# DOCUMENT REVIEW Comment Sheet

<b>Completed by LCP Representative</b>				<b>Completed by LCPDCC</b>	
Document Title:				Record Number:	
Final Engineering Assessment Report of Draft Tube #2 Formwork/Falsework Failure					
NE-LCP Document Number:	Revision:	3 <sup>RD</sup> Party Document Number:	Revision:	Transmittal Number:	
MFA-AT-SD-331A-EN-A99-0031-01	B1	A-DT000-NA-CV-D31-031-01	A		
LCP Department of Origin:		Purchase Order/Contract Number:		Transmittal Date:	
Distribute Comment Sheet to:		Date returned to LCPDCC

<b>Company's 3<sup>rd</sup> Party Engineer (aDB Structural Engineering Inc.) Comments</b>				
		Please see attached copy of mark-up comments provided by aDB.  In addition a copy of aDB's Final Report is attached for Reference.		
<b>Company's Engineer (SLI) Comments</b>				
2	Page 1/ Section 1.1 Description	<b>Page 1 / Section 1.1 Description</b>  <b>Recommend adding the following two paragraphs between the 4<sup>th</sup> and 5<sup>th</sup> paragraph of section 1.1 Description</b>

Figure 34: Isometric View of ILF's 3D Structural Model

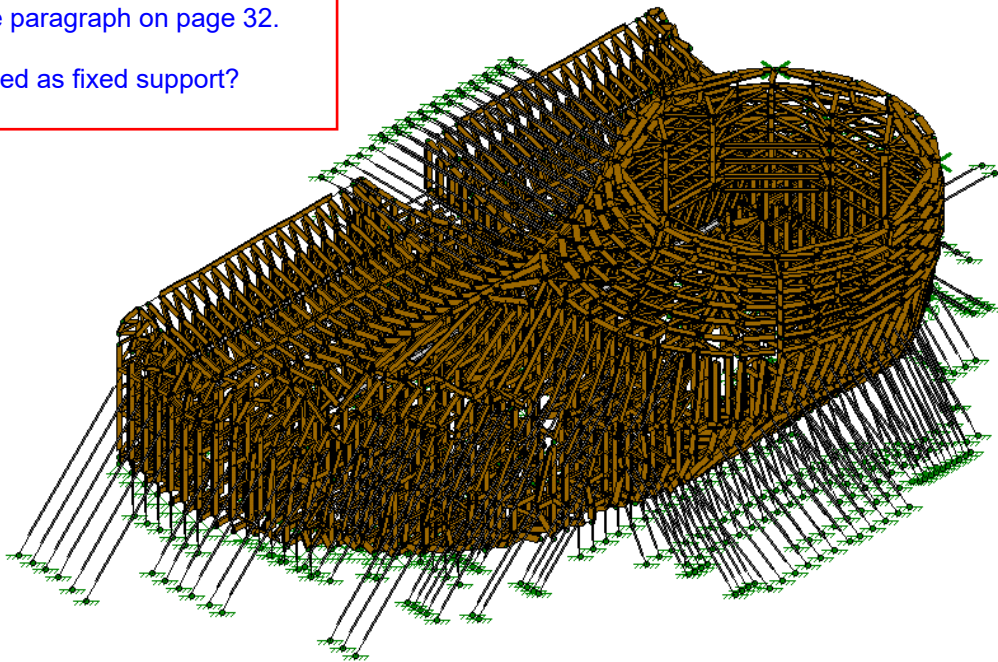
Are the ties modeled as fixed support?
